From: Ed Squires
Sent: Monday, February 03, 2014 2:13 PM
To: Shelley Keen
Subject: 2-1-2014 City of Meridian Response to Hemenway Letter of 1-27-2014 Concerning Permit No. 63-31630
Importance: High
Attachments: 2-3-2014 HLI Response to Sandy Hemenway Letter of January 27, 2014 Concerning Permit No. 63-31630 with Figures.pdf

January 31, 2014

Subject: City of Meridian Water Right Permit No. 63-31630 (City Wells #25 and #28)

Figure 1.

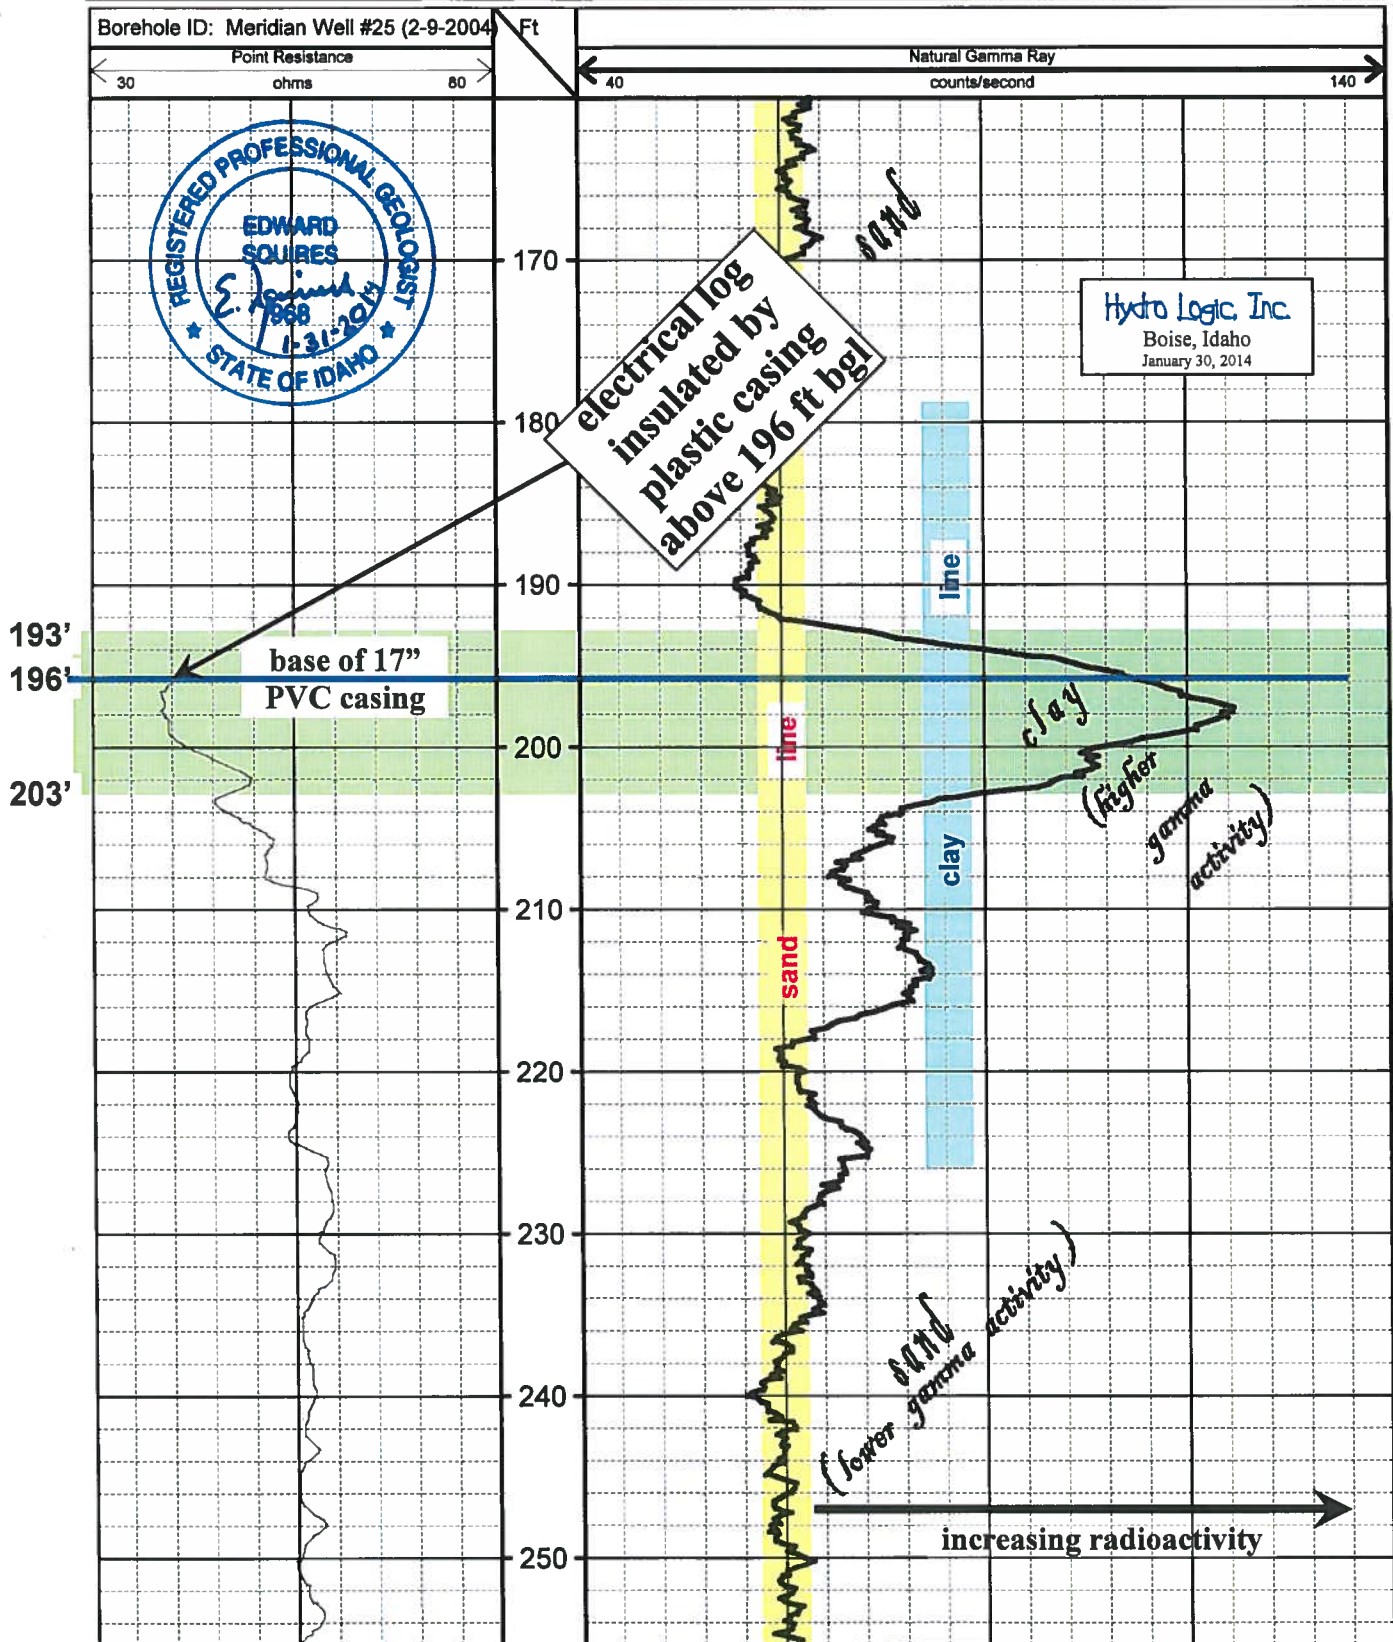
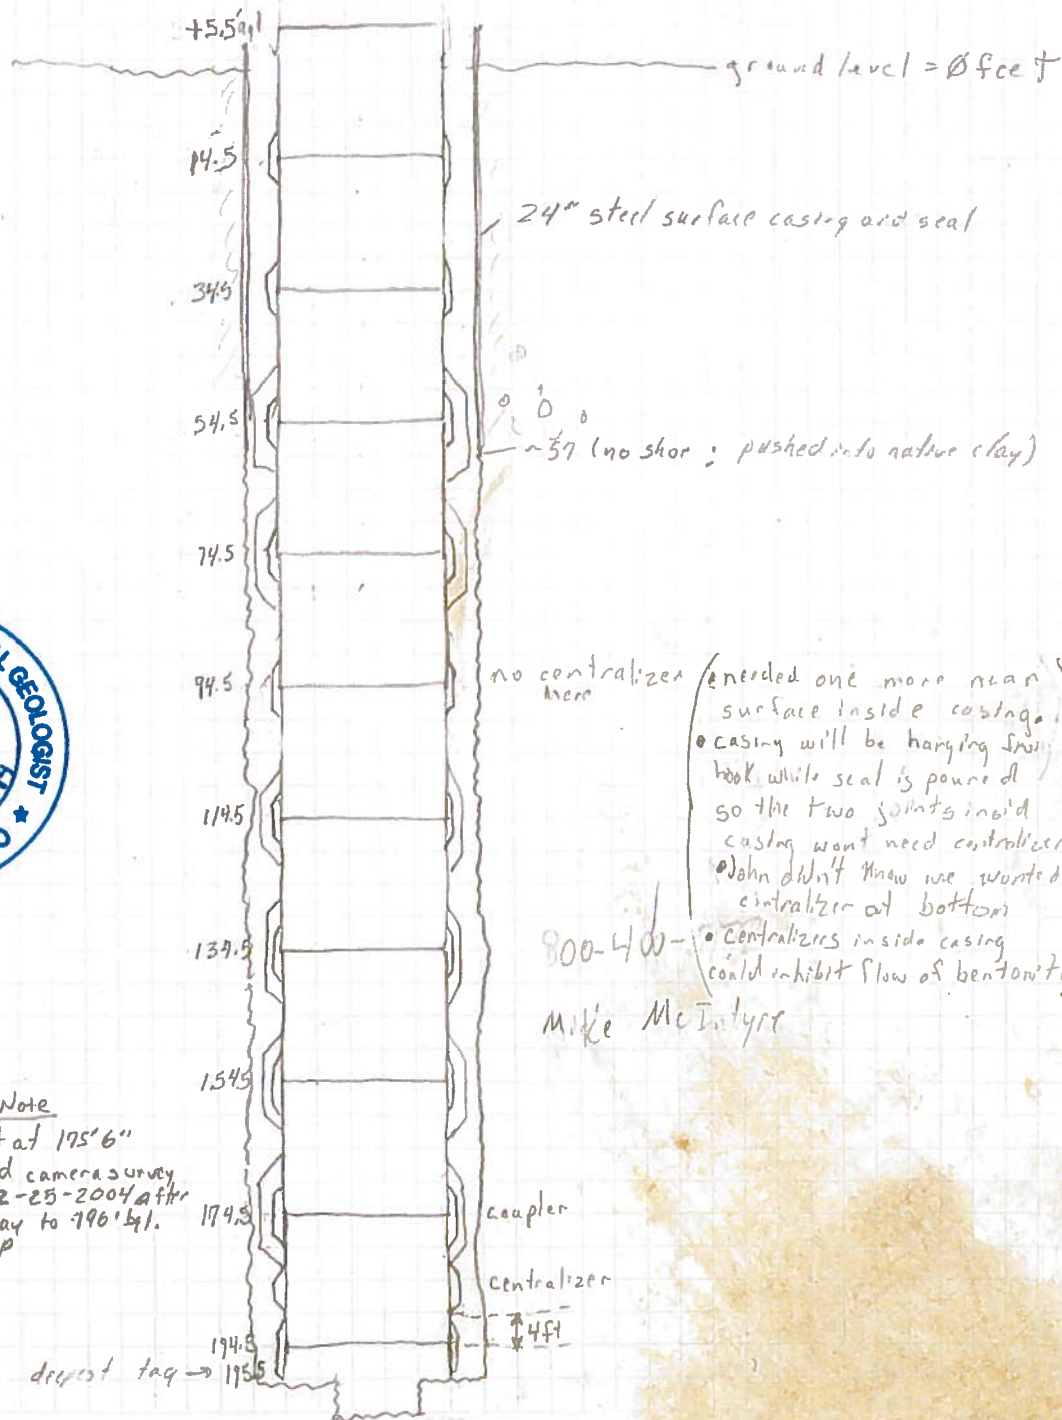
- iii. Therefore, the assertions of Concern No. 1 are incorrect. First, Well #25 is in compliance with the Permit condition No. 9 because the unperforated surface casing extends from land surface to a confining layer directly overlying the top of the aquifer open to the wells. As shown on Figure 11 of the Exam, the "sticky" clay layer into which the casing is terminated (Figure 1 of this document) is also the most significant (thickest and least permeable) unit in the 336 drilled geologic section of Well #25. Secondly, the well screen interval does not begin "at 183 feet, in a sand and gravel sequence that extends from 105 to 194 feet." As Figure 11 of the Exam and the Well Driller's Report (Attachment A) show, the first screen interval outside the primary casing is at 196 ft bgl and the first screen open to permeable aquifer sands is at 203 ft bgl.

- c. The primary (pump-chamber) casing string ends at 196-ft bgl, not the 195-ft suggested by the IDWR reviewer in the Letter. The one foot difference is technically significant so I have attached geophysical data, underwater camera, inspection notes, on-site measurement data, and the Well Driller's Report (Figure 2-4 and Attachment A of this report) to confirm the seated depth of the casing which we extended to the central and most dense portion of the clay at 196 ft bgl (Figure 1 this report).

Figure 1. A section of the borehole geophysical logs from the City of Meridian municipal supply Well #25. These annotated strip charts depict the characteristically high natural gamma-ray response of a sticky clay stratum (highlighted in green) located between 193-to-203 ft below ground compared to the lower gamma activity characteristic of clean sands. The single point resistance electrical log on the left shows low resistance in the clay and high resistance in the sand. Together with the drill cuttings, these logs confirm the existence and depth of the clay stratum the Well #25 casing is sealed into at 196 ft bgl.
